MEMORANDUM

Updated Information for Final EIR/EIS

PREPARED FOR: Russ Stein/DWR
PREPARED BY: Gwendolyn Buchholz/CH2M HILL
DATE: May 19, 2016

Figure 1
Changes to Groundwater Elevations due to Dewatering Actions
with and without Slurry Cutoff Walls

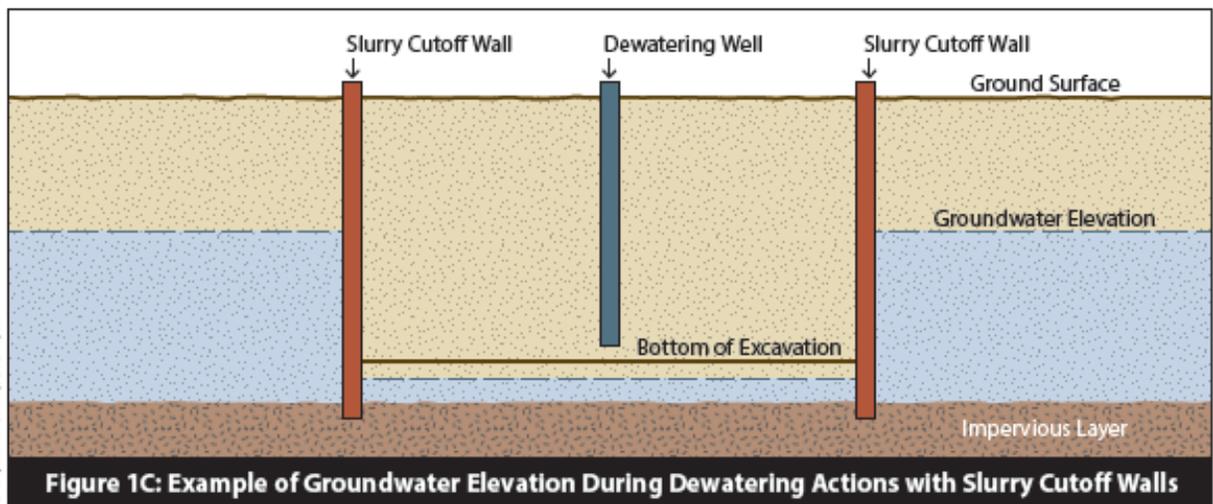
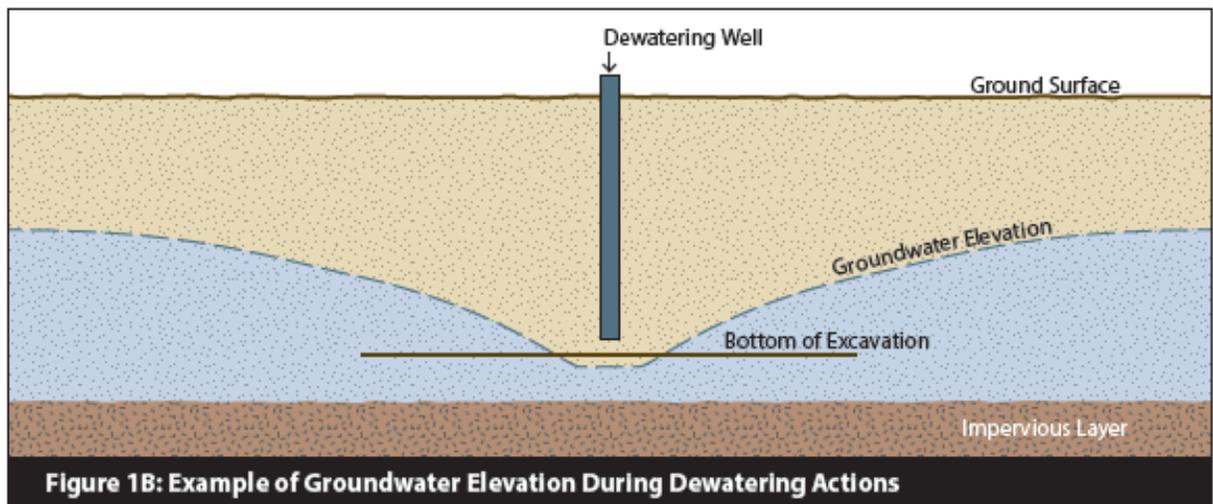
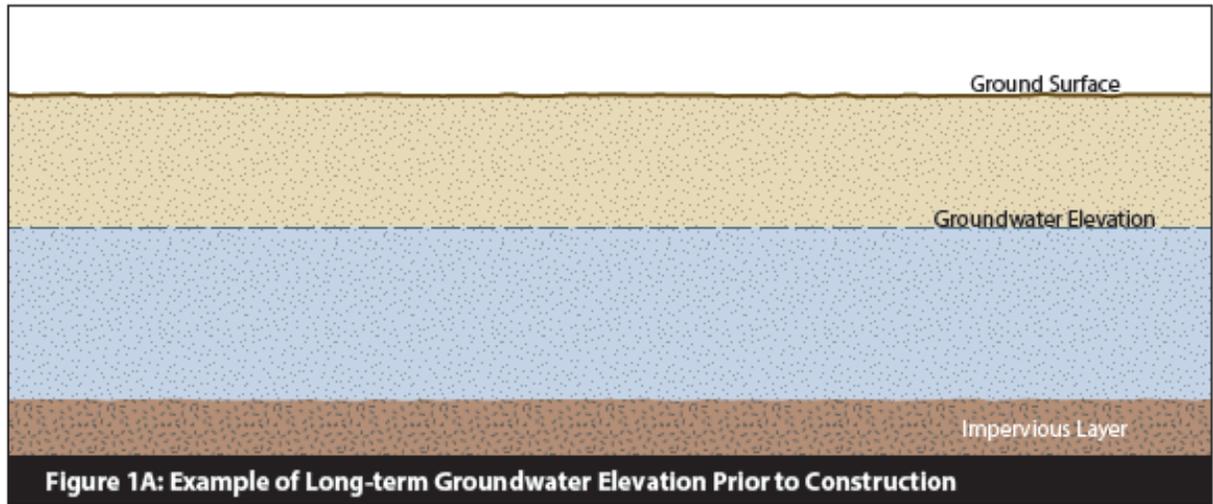
Based upon this additional information provided to the EIR/EIS groundwater impact analysis team related to the use of slurry cutoff walls to be installed around the intake locations, tunnel shafts, and forebays, the revised impact analysis results indicate that the extent of changes in groundwater elevations near these construction sites would be substantially reduced from those described in the DEIR/DEIS and RDEIR/SDEIS. Based upon the use of slurry cutoff walls at the intake locations, tunnel shafts, and forebays, it is anticipated that potential adverse impacts identified in the DEIR/DEIS and RDEIR/SDEIS would be reduced to a level of less than significant. It is assumed that the mitigation measures would continue to include a monitoring program and commitments included in Mitigation Measure GW-1 to extend the depth of groundwater wells if groundwater elevations declined below the pump inlets as compared to pre-construction conditions.
